Design Review Board – Neighborhood Panel

Agenda Workshop

**Planning Staff Report to
Design Review Board - Neighborhood
May 24, 2022**
for the June 2, 2022 Public Hearing

**Planning Staff Report to
Design Review Board - Neighborhood
May 17, 2022**
for the June 2, 2022 Public Hearing

Existing Rear Elevation w/ Demo
1/4" = 1'-0"

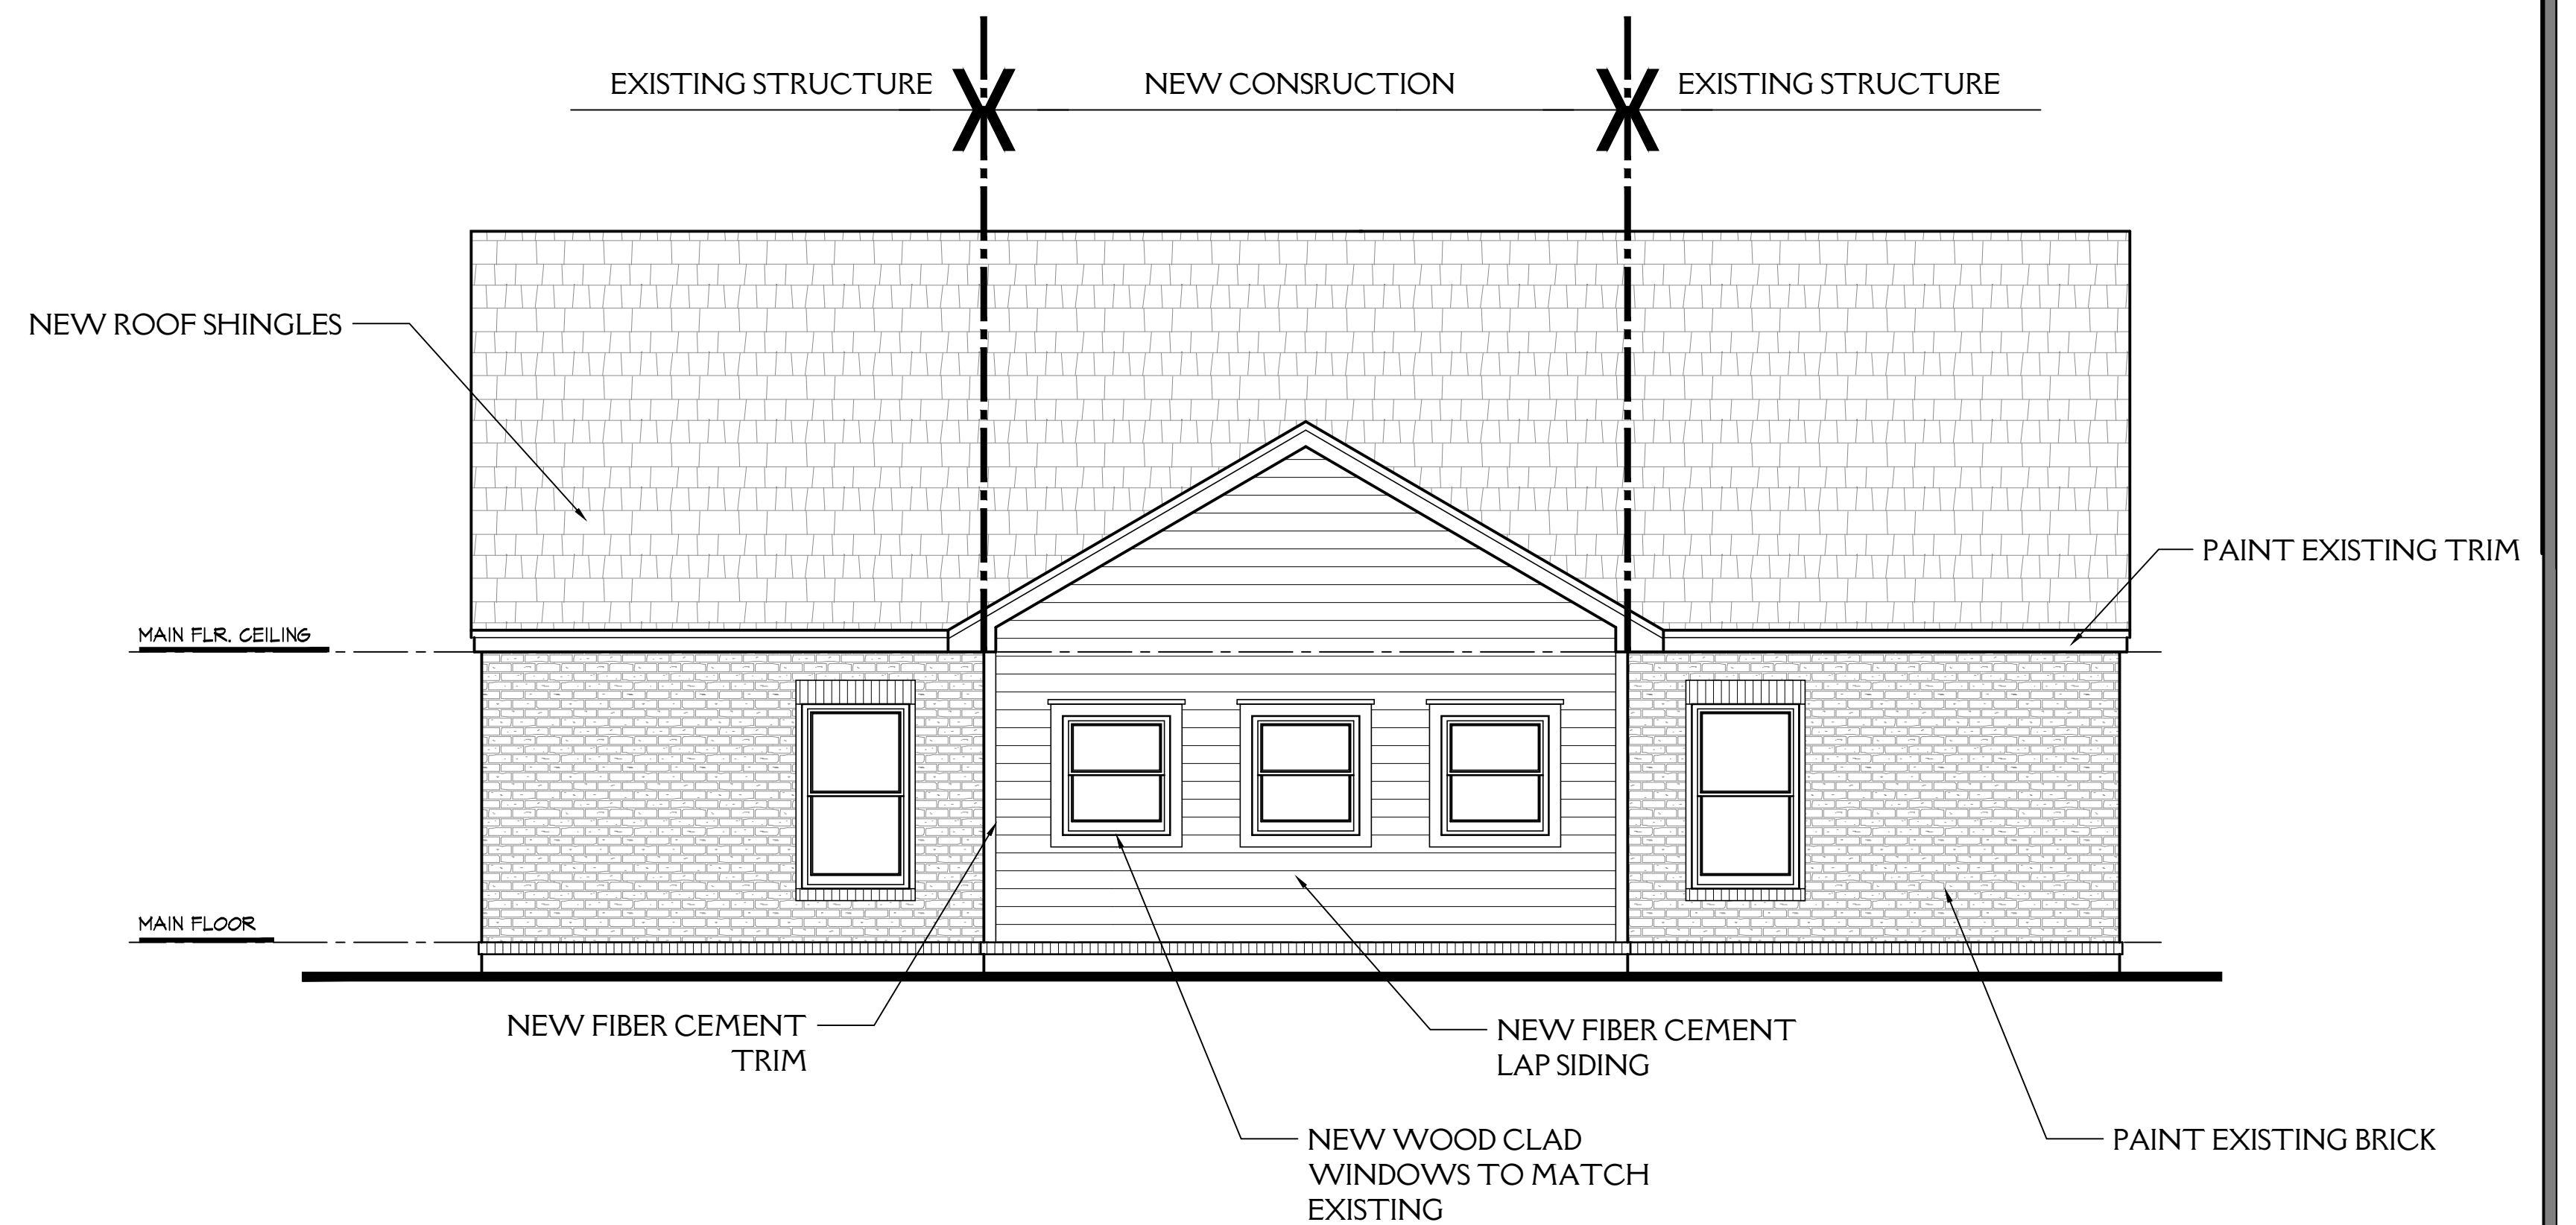
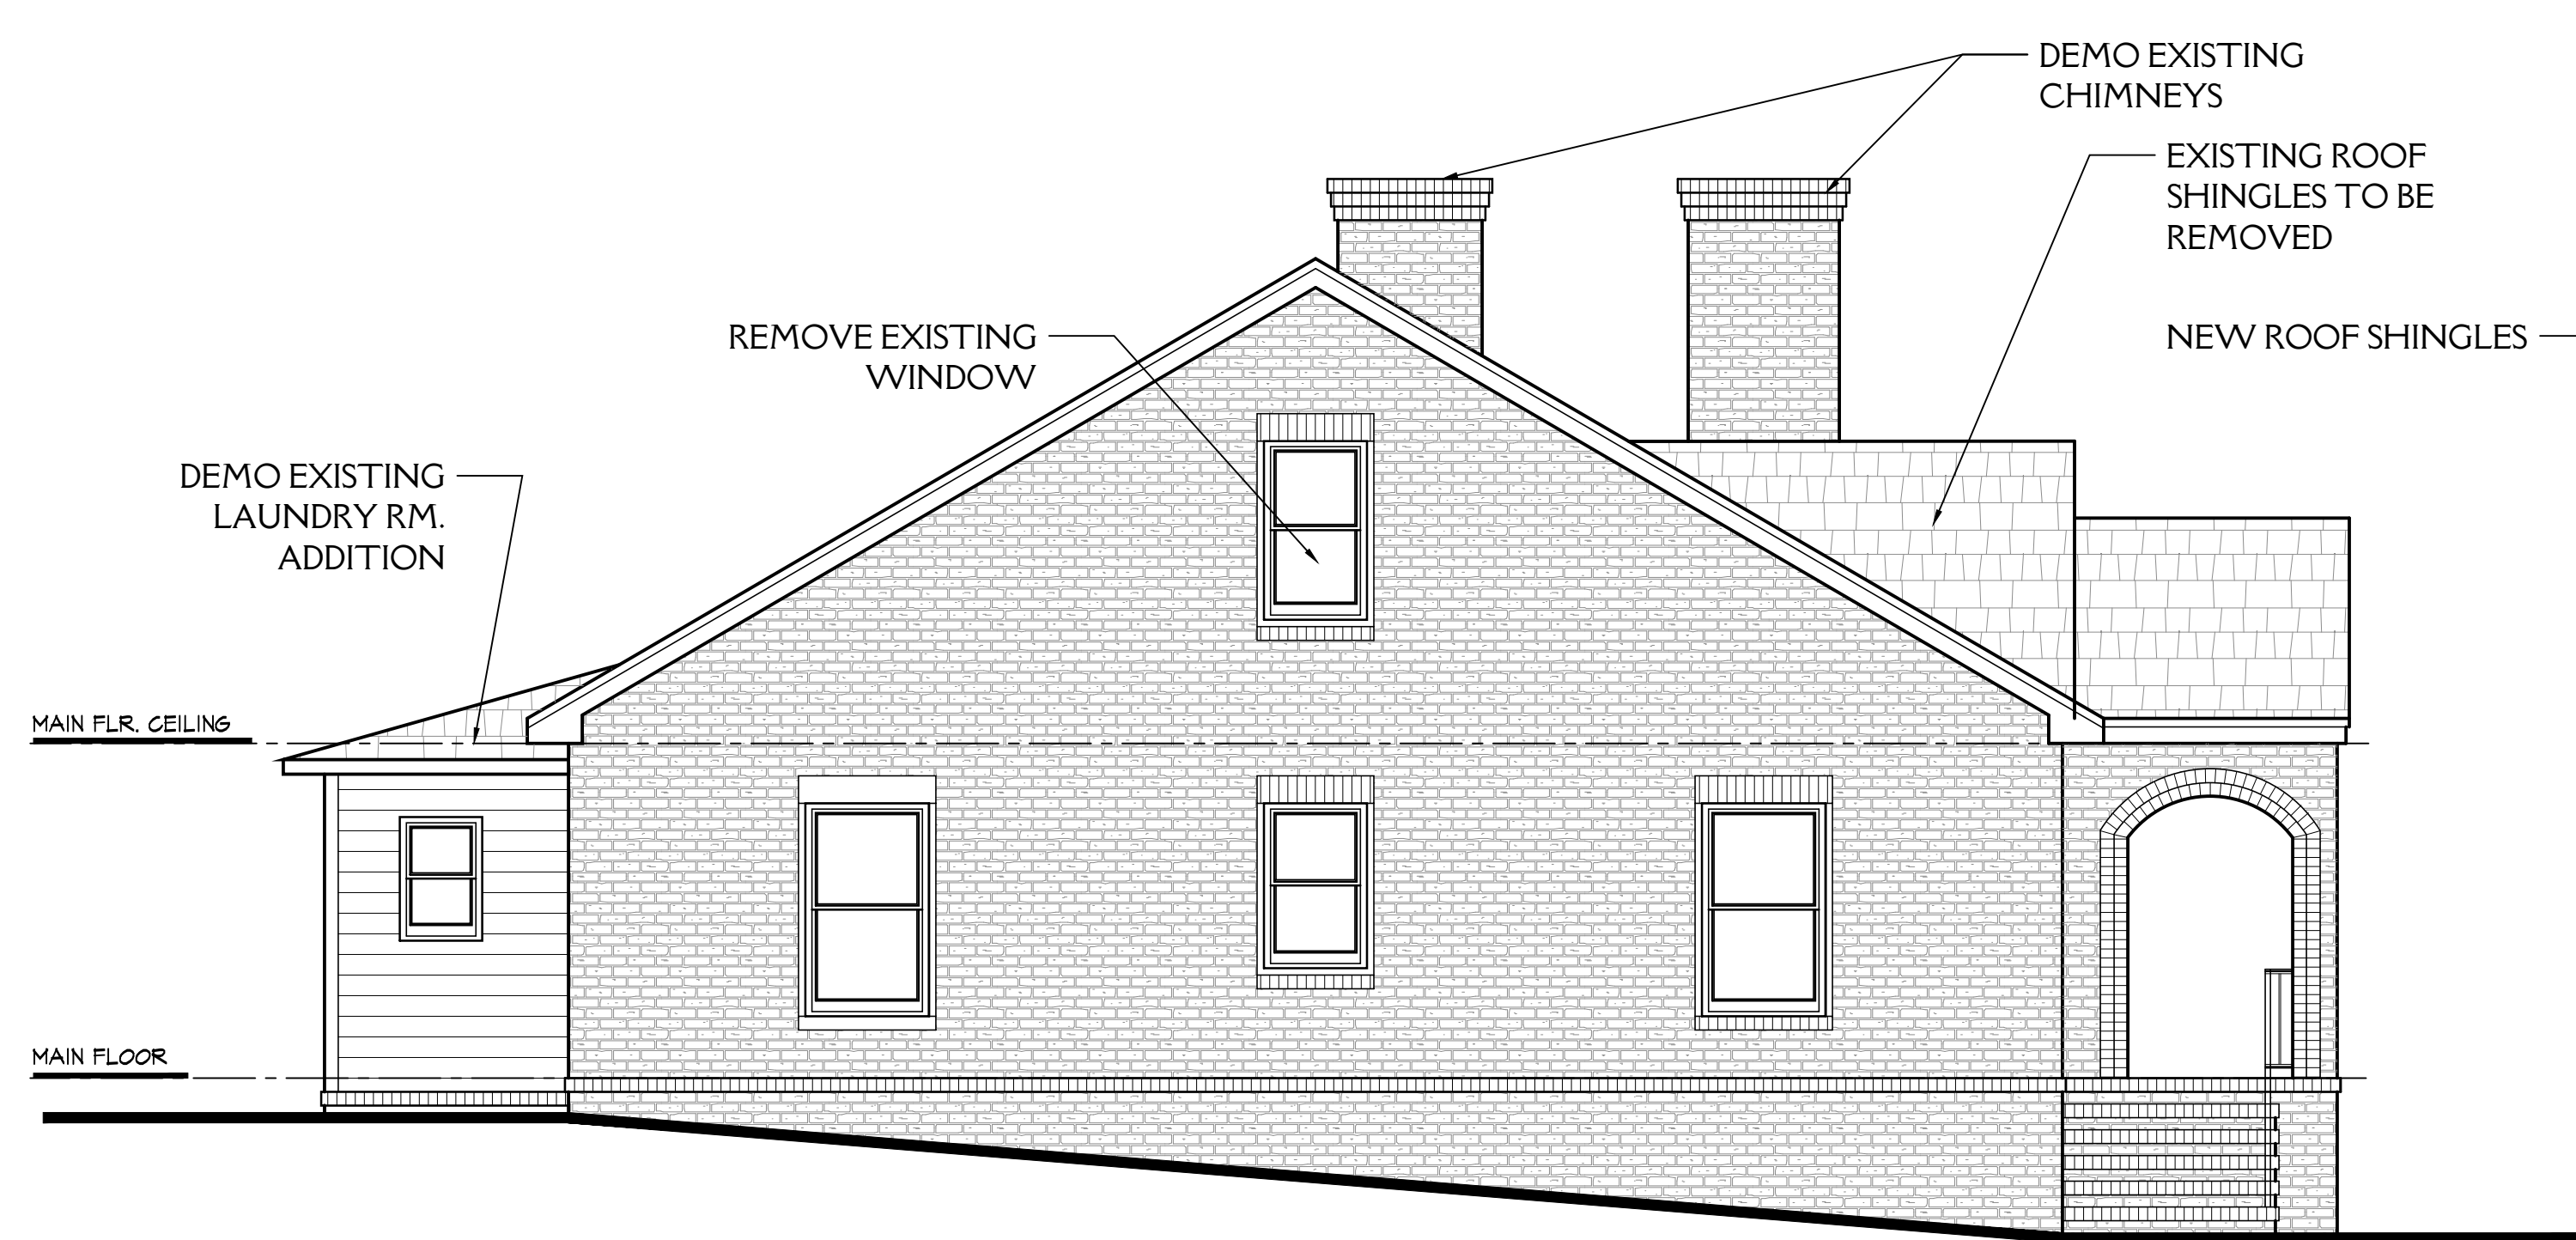
The proposed materials of Hardie Plank are suitable for the new rear addition, but the historic brick should be maintained and preserved on the remainder of the house and not painted as is proposed. HR.9 Masonry Construction, recommends that brick that was not painted historically should not be painted.

Staff finds that removal of the chimneys is not compatible with the design guidelines outlined in Chapter 9. Overbrook Historic District. The introduction specifically calls out chimneys as contributing to the historic district and should be maintained. While Design Guidelines do not dictate interior modifications and would therefore allow for the proposed removal of the fireplaces the existing historic chimneys should be preserved. Structural engineering efforts should be made to maintain the existing elevation of the house.
